SARA reference: 1911-13966 SRA
Council reference: D/99-2019

SARA response—98 - 1002 Yaamba Road, Parkhurst; 1014 - 1016 Yaamba Road, Parkhurst

(Referral agency response given under section 56 of the *Planning Act 2016*)

Description:	Development permit	Material Change of Use for Short-term Accommodation and a Relocatable Home Park.
SARA role:	Referral Agency.	
SARA trigger:	Schedule 10, Part 9, div 4, sub 1, table 1 (Planning Regulation 2017)— Development application for a material change of use for an aspect of development stated in Schedule 20: Development impacting on State transport infrastructure and thresholds

Figure 4.2 Access Arrangement Proposed in RNAU Documentation (from August 2018)

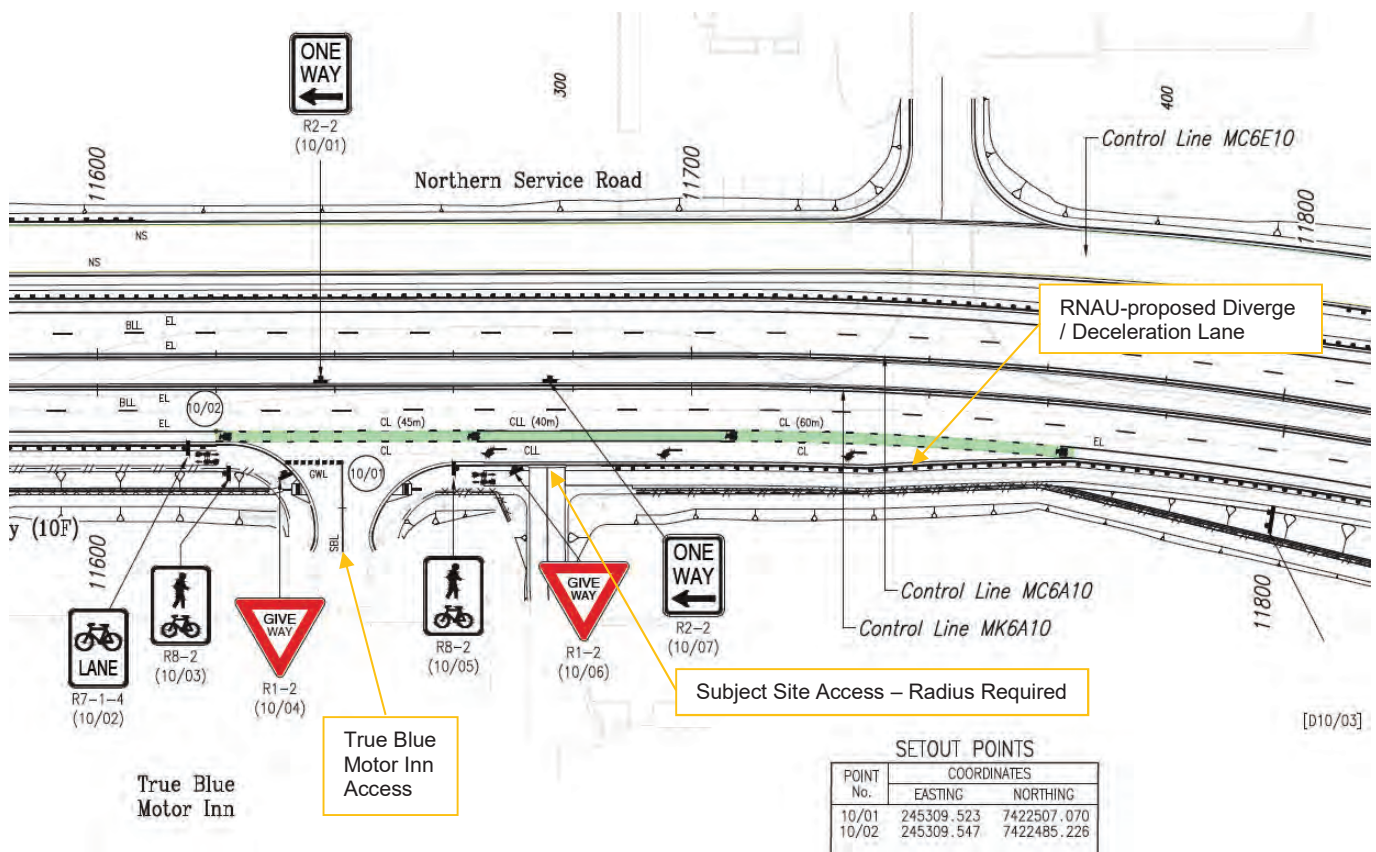
generally in accordance with the Concept Road Functional Layout Plan shown in Figure 4.2 and Figure 4.3 of the <i>Engineering Infrastructure Report Proposed Development, 1014-1016 Yaamba Rd, Parkhurst</i> prepared by Calibre Professional Services Pty Ltd, dated 10 October 2019 and reference 18-002864. (b) Road access works comprising a fully lit Auxiliary Left Turn (AUL) treatment (at the road access location) must be provided generally in accordance with the Concept Road Functional Layout Plan, Figure 4.2 of the Calibre Professional Services Pty Ltd. Engineering Infrastructure Report 18-002864 dated 10 October 2019 by Calibre Professional Services Pty Ltd, including widening of the access throat (in accordance with Figure 4.3) to accommodate the simultaneous left in/left out movements of the maximum sized design vehicle (8.8m Medium Rigid Vehicle (MRV)). (c) The road access works must be designed and constructed in accordance with the relevant Department of Transport and Main Roads' Road Planning and Design Manual (2nd Edition) and Austroads Standards.	(b) and (c): Prior to the commencement of use.

No.	Conditions of Approval	Condition Timing
1	The road access location is to be located at approximate Chainage 11,7km (RHS) (lat -23.286790; long 150.510012) and generally in accordance with the Concept Road Functional Layout Plan shown in Figure 4.2 and Figure 4.3 of the Engineering Infrastructure Report 18-002864 dated 10 October 2019 by Calibre Professional Services Pty Ltd, prepared for G & M Demedio for the Proposed Development, 1014-1016 Yaamba Rd, Parkhurst.	At all times.
2	Road access works comprising a fully lit AUL, (at the road access location) must be provided generally in accordance with the Concept Road Functional Layout Plan, Figure 4.2 of the Calibre Professional Services Pty Ltd Engineering Infrastructure Report 18-002864 dated 10 October 2019 by Calibre Professional Services Pty Ltd, including widening of the access throat (in accordance with Figure 4.3) to accommodate the simultaneous left in/left out movements of the maximum sized design vehicle (8.8m Medium Rigid Vehicle (MRV)).	Prior to commencement of use.
